SUBJECT: Transmittal of Response to PRP Complaint Regarding Well
Installation Activities at the Richardson Flats Tailings Site;
TDD #T08-9207-019

TAT Response to Pioneer Technical Services, Inc.
Comments and Observations Report
Dated July 13, 1992

COMMENTS AND OBSERVATIONS
ON THE DRILLING ACTIVITIES PERFORMED BY
EPA's TAT CONTRACTOR
AND SUBCONTRACTED DRILLER
DURING THE PERIOD OF
JUNE 23 THROUGH JUNE 27, 1992

Subject - Monitoring well installation at the Richardson
Flats Tailings Site, Summit Co., Utah TDD# T08-9204-015

FIGURE 2
GEOLOGIC CROSS SECTION
AND LANDFILL MONITORING WELLS

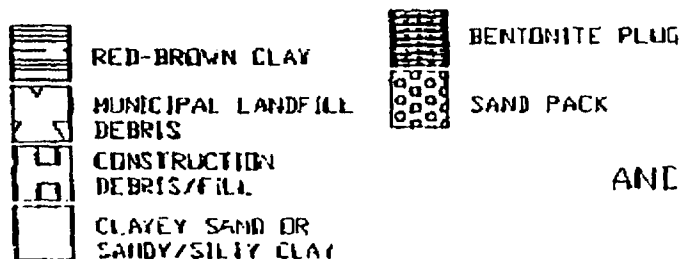
- ~~the~~ apparently irreconcilable descriptions of
geologic conditions observed during logging by
the TAT, and those described by PTS in their text;
- the preparation of a cross-section by PTS
which is not compatible with well logs prepared
by the TAT and not substantiated by any alternative
well logs;
- a plan of the ~~site~~ site prepared by PTS which

places the monitoring wells at different distances from each other than does the ~~the~~ PTS cross-section

FIGURE 1
WELL AND LANDFILL
LOCATION MAP

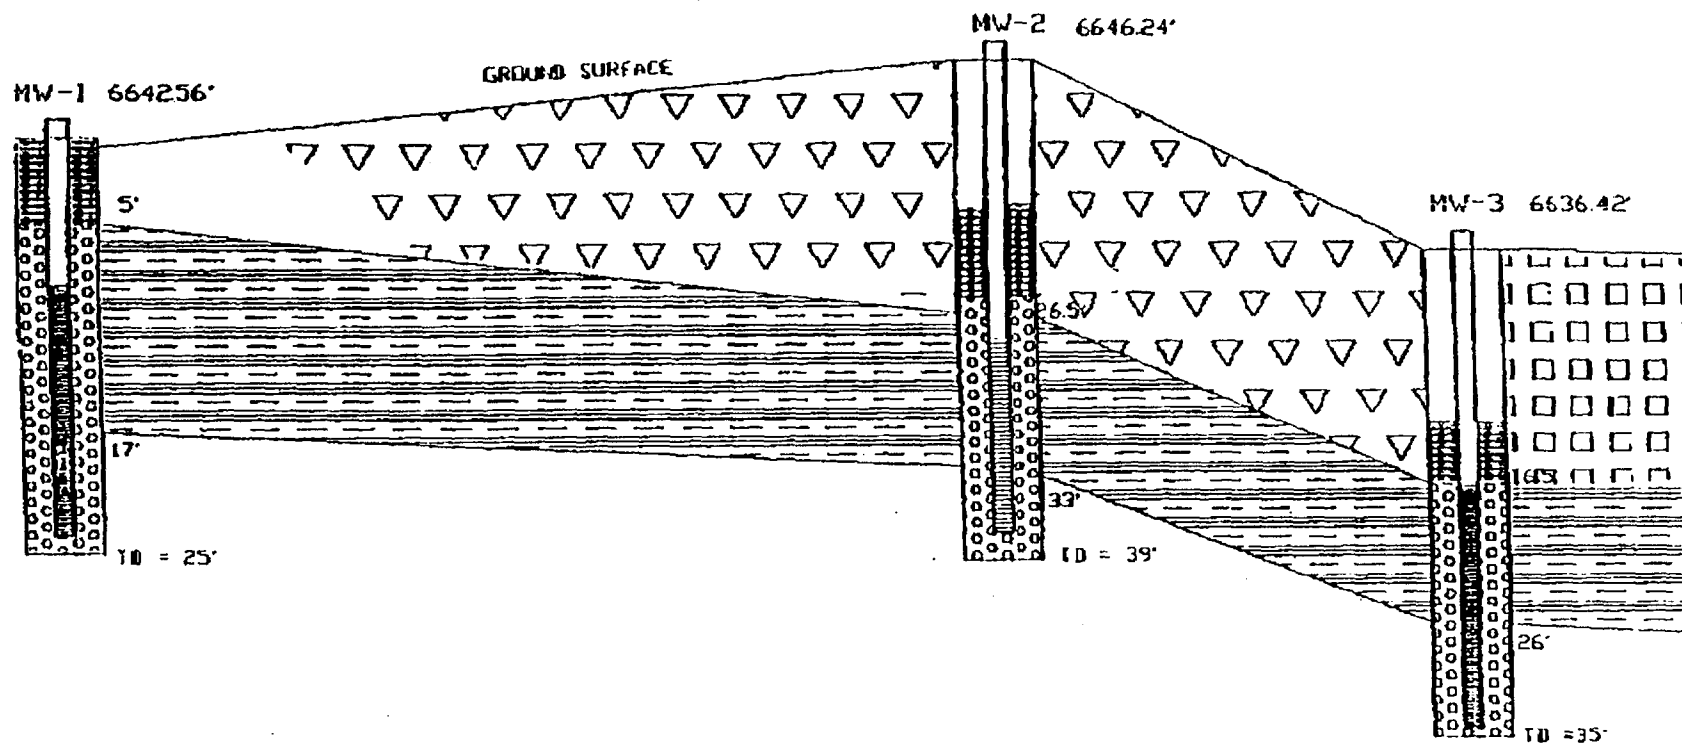
The most blatant violation of EPA guidance in the drilling of these monitoring wells was the placement of well MW-2 within the boundary of the historic landfill (see Figure 1). USEPA direction is clear - drilling directly through municipal landfills is to be avoided in order to protect underlying groundwater, and for obvious safety considerations; rather, drilling is to be conducted off of the actual landfill and downgradient from it. Prior to drilling, the TAT was advised by the property owner (UPCM) that the location selected for MW-2 was within the former landfill boundary. For whatever reasons, the TAT declined to relocate the well 100 feet to the north, out of the former landfill. After drilling five to ten feet, drill cuttings and split-spoon sample cores showed that the borehole was obviously within the landfill.

Contrary to statements made by the consultant, there are no references in EPA guidance or State of Utah administrative regulations prohibiting drilling in landfills. TAT believes that well RF-MW-02 is actually located in an optimum location in order to detect leachate emanating from beneath the landfill.

RICHARDSON FLATS TAILINGS SITE - SUMMIT CO. UTAH
 CROSS-SECTION THROUGH TAT BOREHOLES
 USING PIONEER TECHNICAL SERVICES ELEVATIONS

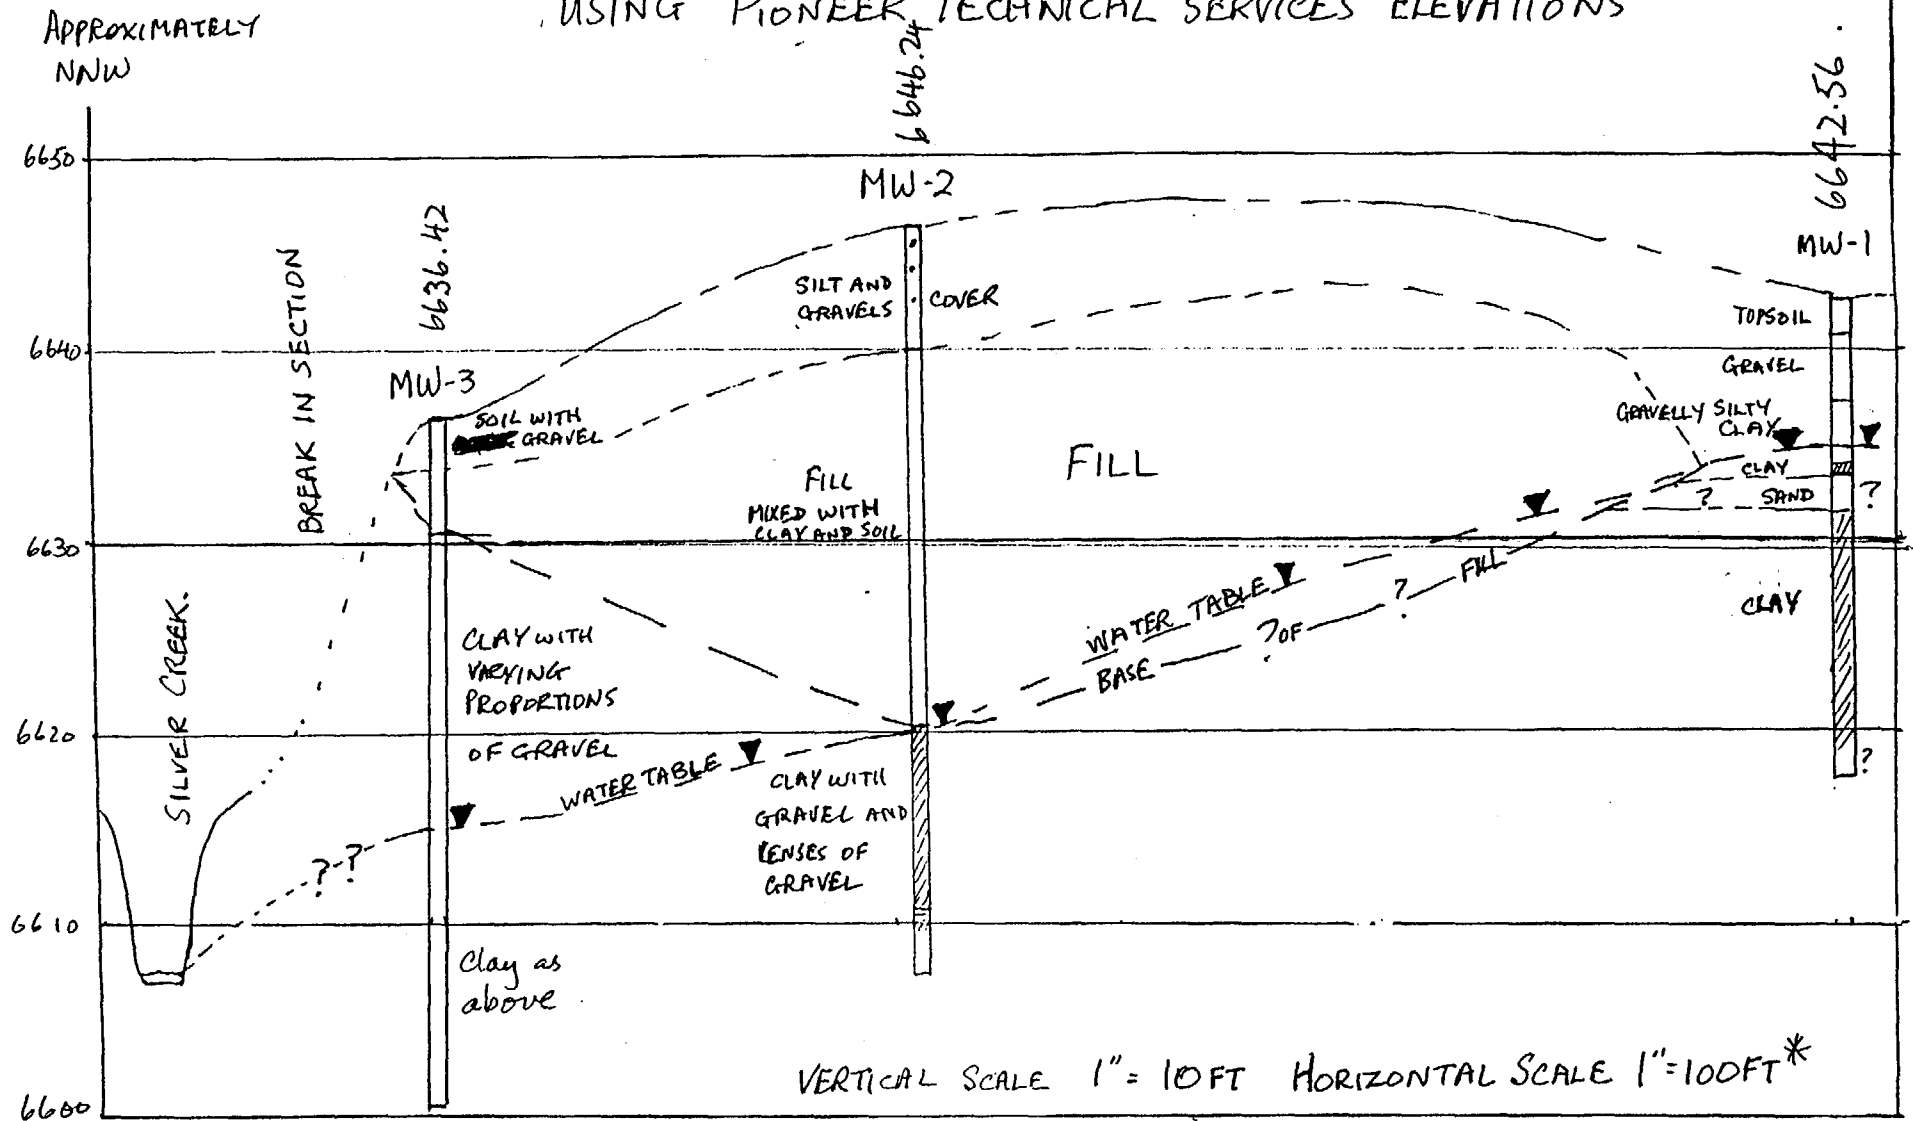
The cross-section of the landfill which I have prepared (see attachment), implies that the elevations of water in the three monitoring wells are compatible with the interpretation, that they are

installed into an unconfined aquifer within a predominantly clay unit containing lenses and stringers of sand and gravel. Please check that the elevations and distances agree with your own surveys.
